ADDENDUM NO. 1

**GREATER DAYTON RECREATION CENTER PARKING LOT EXPANSION
(10% MBE AND 15% HUD SECTION 3 PARTICIPATION GOAL)
(FEDERAL CDBG FUNDS)
JULY 23, 2018**

ITEM NO. 1 – SUBSTITUTE DRAWING SHEETS

GREATER DAYTON
RECREATION CENTER
PARKING LOT
LAYOUT AND UTILITY PLAN

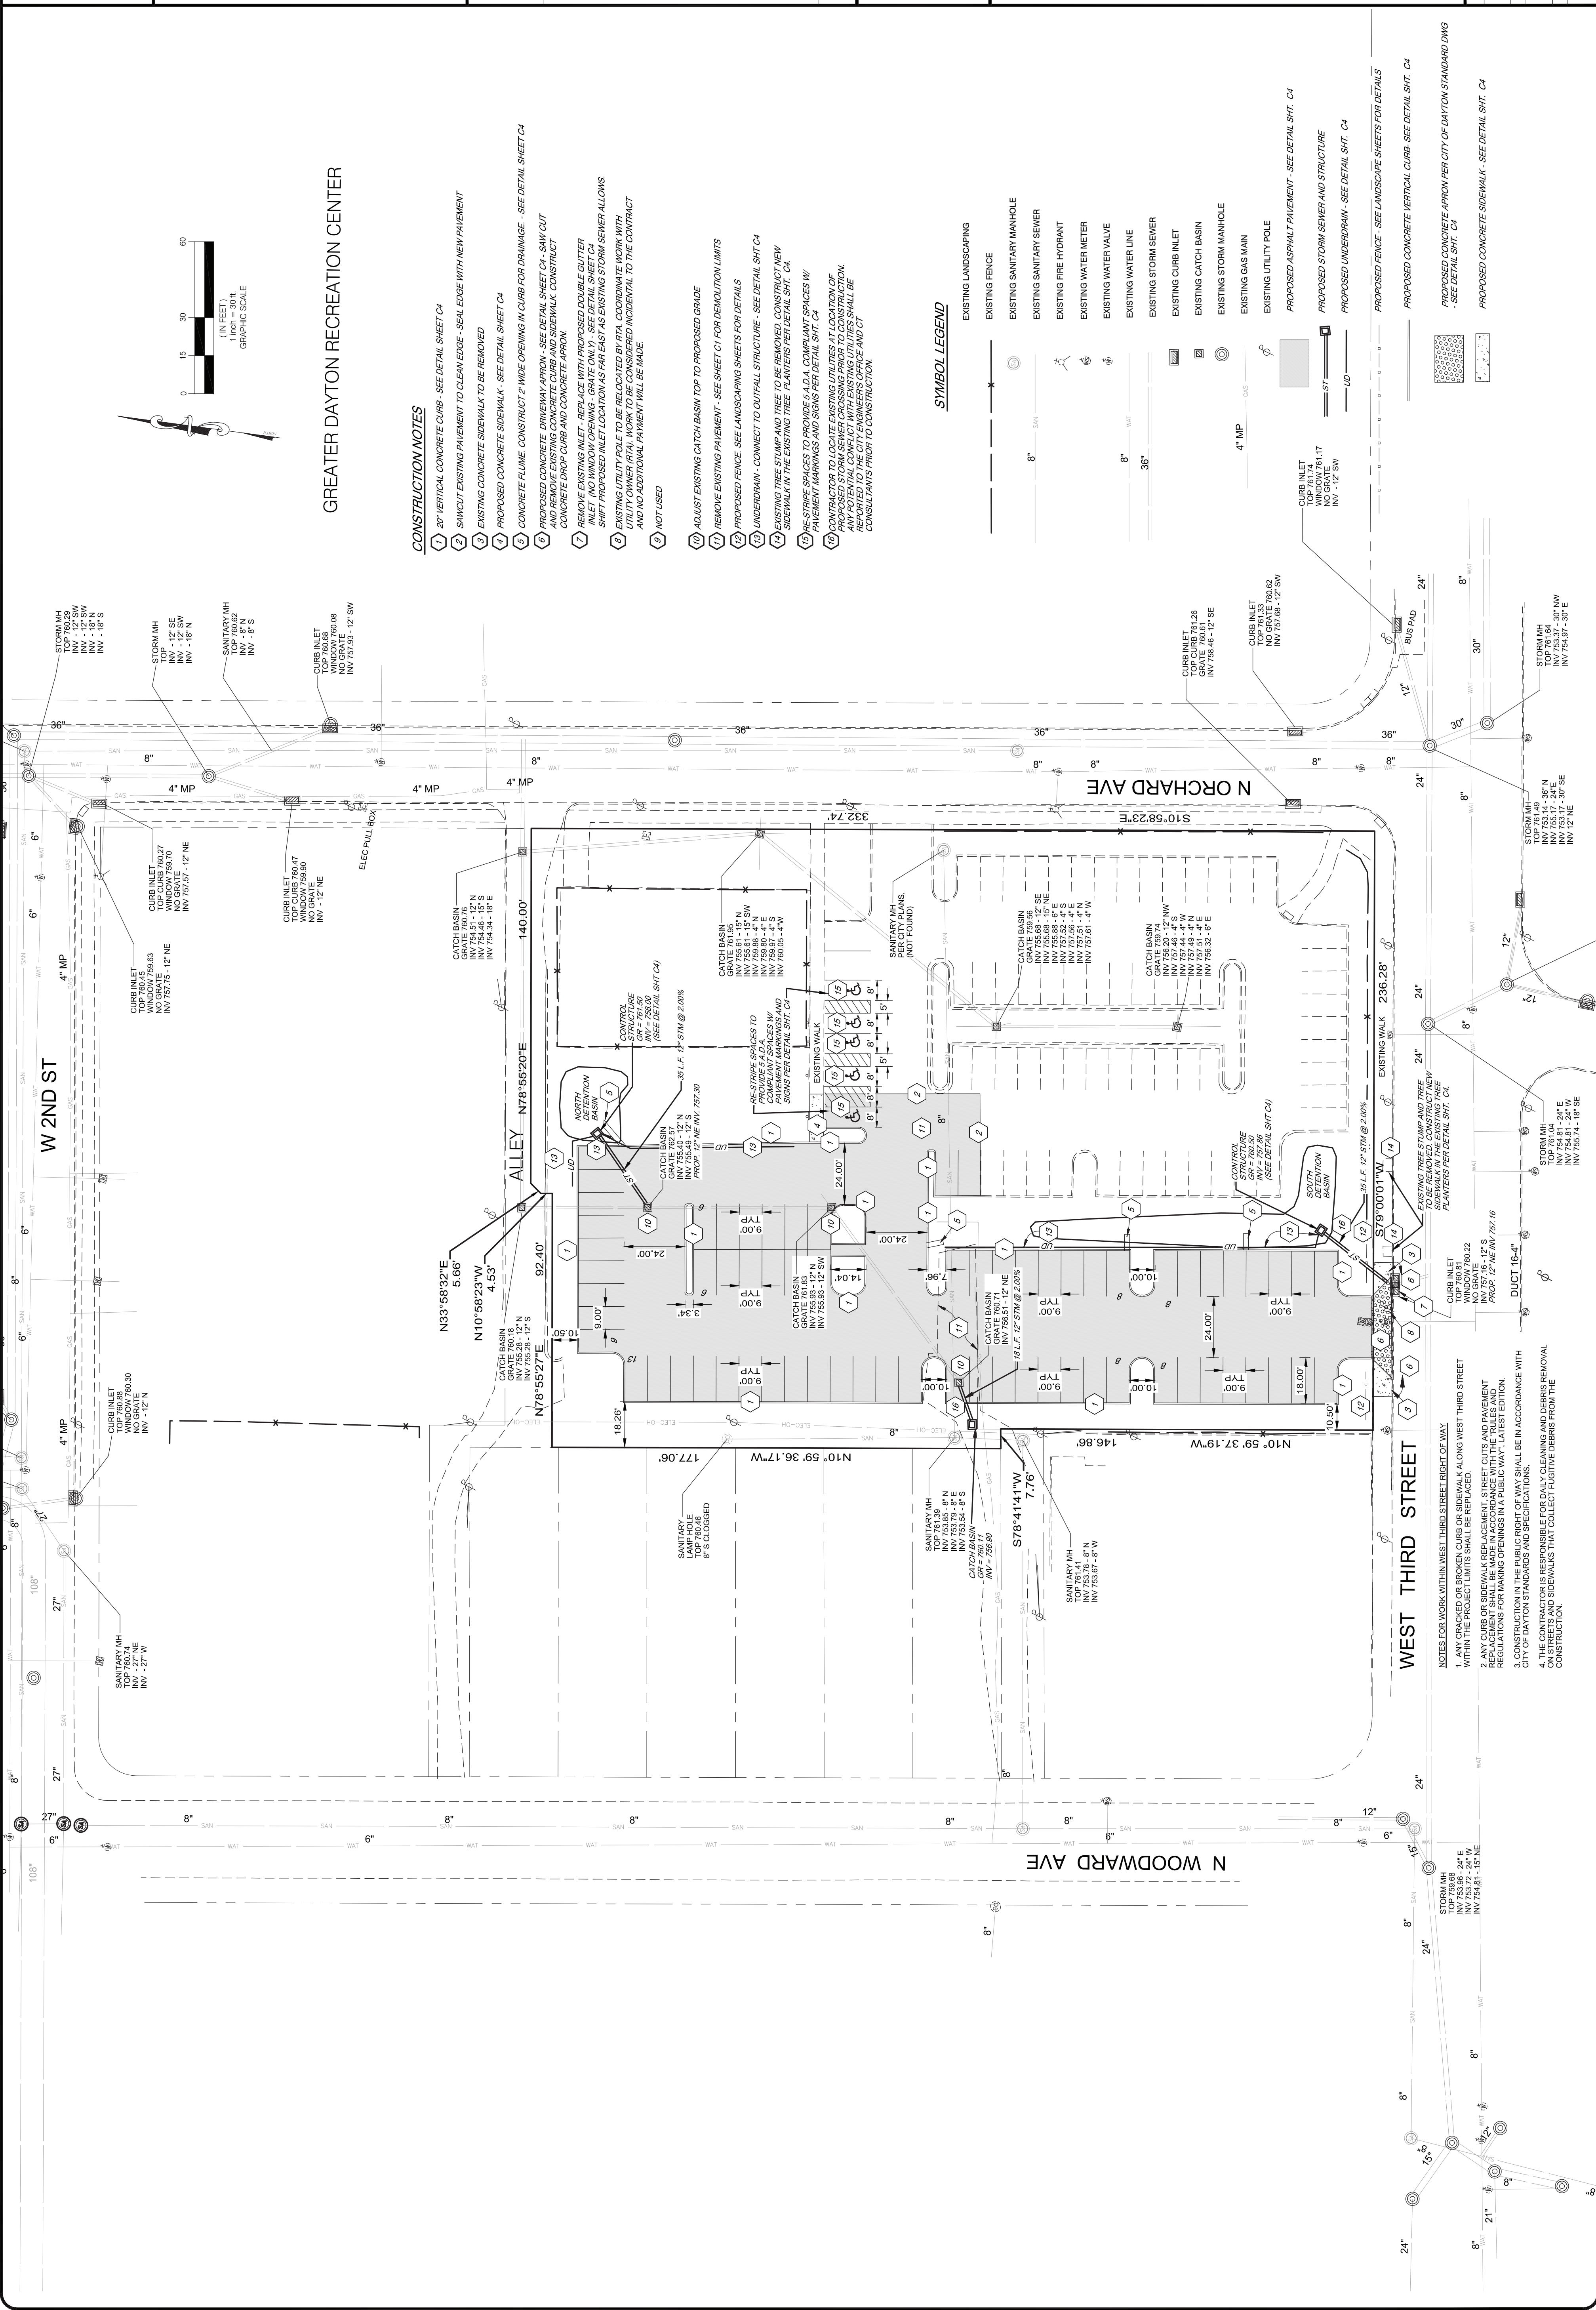
Substitute the following attached Drawing Sheets in their entirety: CT2 & CT4. Drawing Sheet CT2 removed language regarding the installation of ADA truncated domes and Drawing Sheet CT4 changed the vertical curb height from 18” to 20”.

- 20" VERTICAL CONCRETE CURB - SEE DETAIL SHEET C4
- SAWCUT EXISTING PAVEMENT TO CLEAN EDGE - SEAL EDGE WITH NEW PAVEMENT
- EXISTING CONCRETE SIDEWALK TO BE REMOVED
